P1844 Bylong Park additional information

Review of Council RFI for proposed Bylong Park Greyhound Farmstay facility

Figure 7.4: Example of a rural property access specifically designed for articulated vehicles

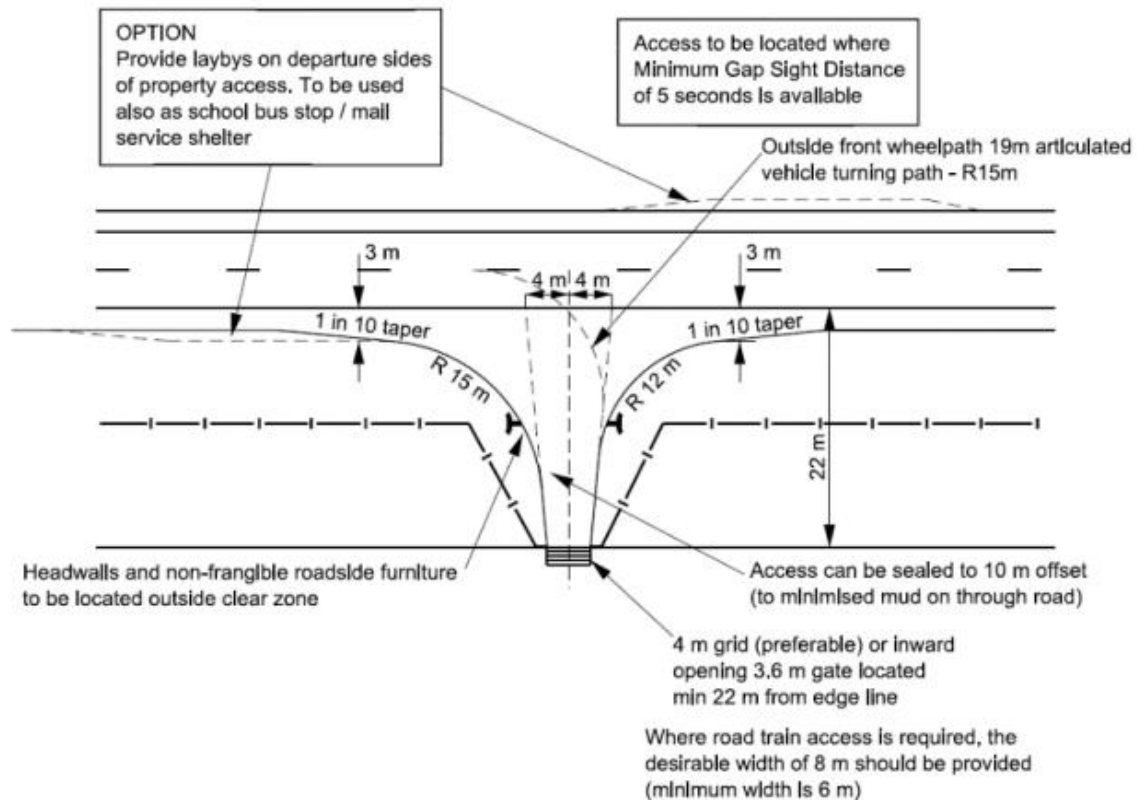
1. **Martindale Road Intersection** – Council Officers have inspected the site and the T intersection between the sealed roadway of Martindale Road and the gravel Crown road to the proposed site. Council Roads and Drainage Officers and Engineers have concerns with the sight distances around this intersection and the risk presented by additional light and heavy vehicle movements using this intersection as an outcome of the proposed development. It is Council's view that this intersection will require upgrade works as part of the development. Accordingly, it is requested that a further evaluation of this intersection is undertaken and a concept design put forward for an upgraded intersection. Any design should include

- a bitumen seal to the extent of the road reserve in accordance with the Rural Road driveway standard plus suitable sealed apron to prevent gravel entering the roadway,

- Appropriate concealed driveway signage along the Martindale Rd in each direction
 - Appropriate widening of Martindale Road to provide safe acceleration/passing lane for vehicles turning right when exiting the T intersection of the Crown Road into Martindale Road

It is proposed that the driveway connection to the site is upgrade in accordance with the requirements of Austroads Guide to Road Design Part 4: Intersections and Crossings. Figure 7.4 of this design guide (reproduced below) provides the requirements for the rural property access design layout which can be used as a basis for the upgrade of this access. This layout includes the access being sealed to minimise dirt being carried from the Crown Road onto Martindale Road.

Figure 1 – Nominated vehicle access route to site (light and heavy vehicles)

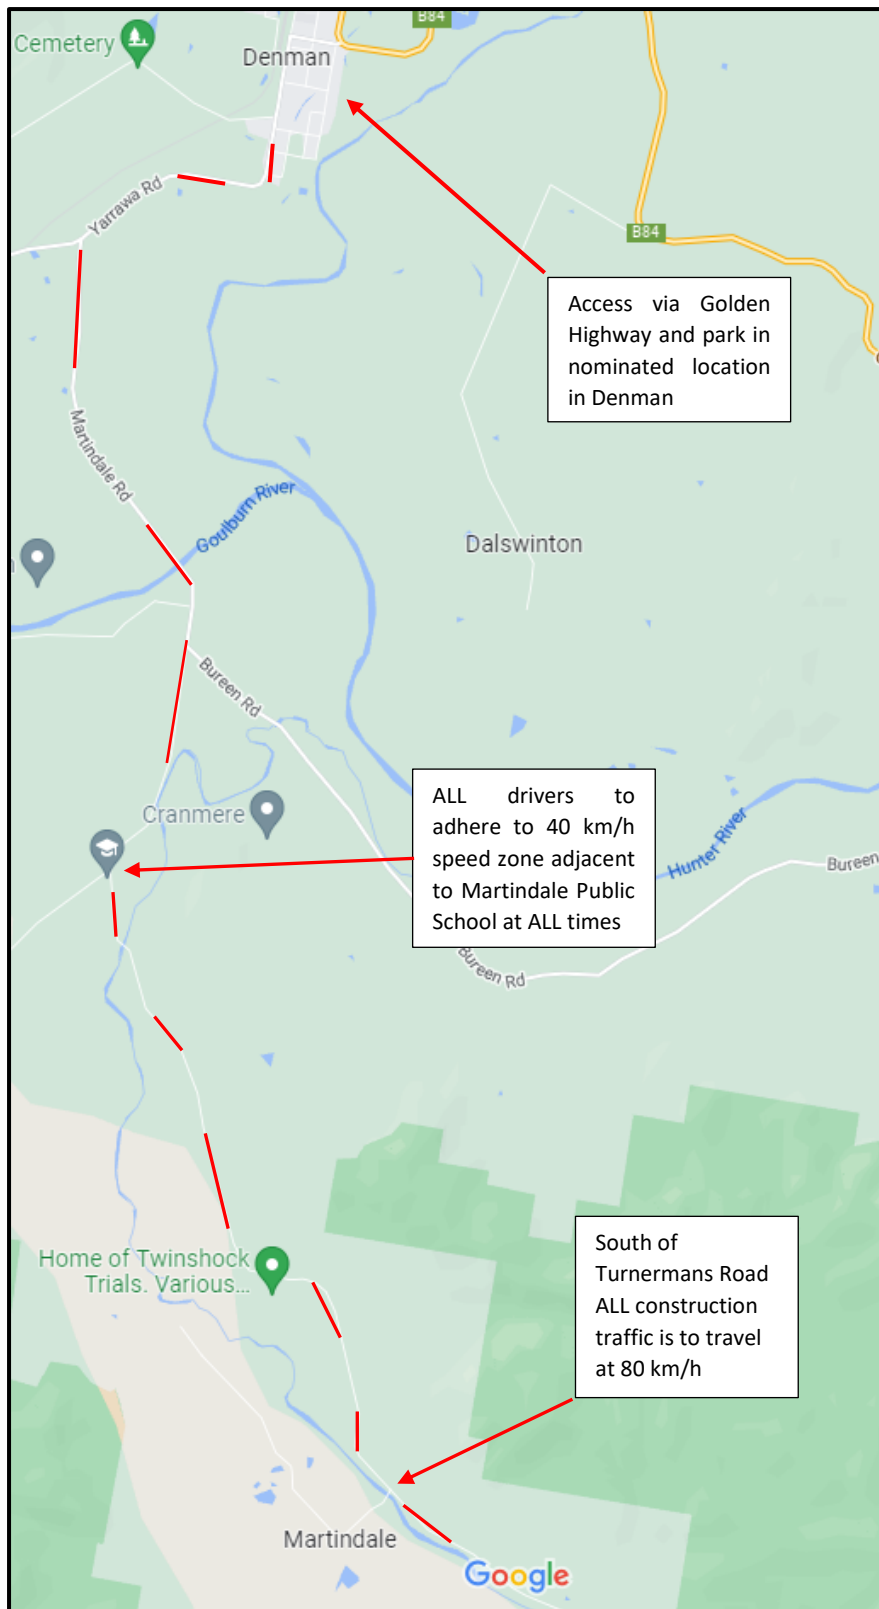
4 Preliminary Construction Traffic Management Plan – while Council recognises that it may be difficult for a comprehensive Construction Management Plan (CTMP) to be prepared at this stage of the development design the ability for construction traffic (particularly heavy vehicles) to safely access the site and avoid conflict with other Martindale Road traffic is an important assessment issue for this development. Accordingly, it is recommended that preliminary details of construction traffic are provided to Council to inform their assessment of the proposed development along with a preliminary Management Plan providing a high level overview of any measures proposed to ensure the safe management of construction traffic to and from the site

- The nominated access route to the site is provided below in Figure 1, for both light and heavy vehicles.
- Provide written communication to all landowners and properties along the access route to advise of upcoming work and any impacts upon Martindale Road. This communication would include the contact details (email and telephone) for the construction site manager.
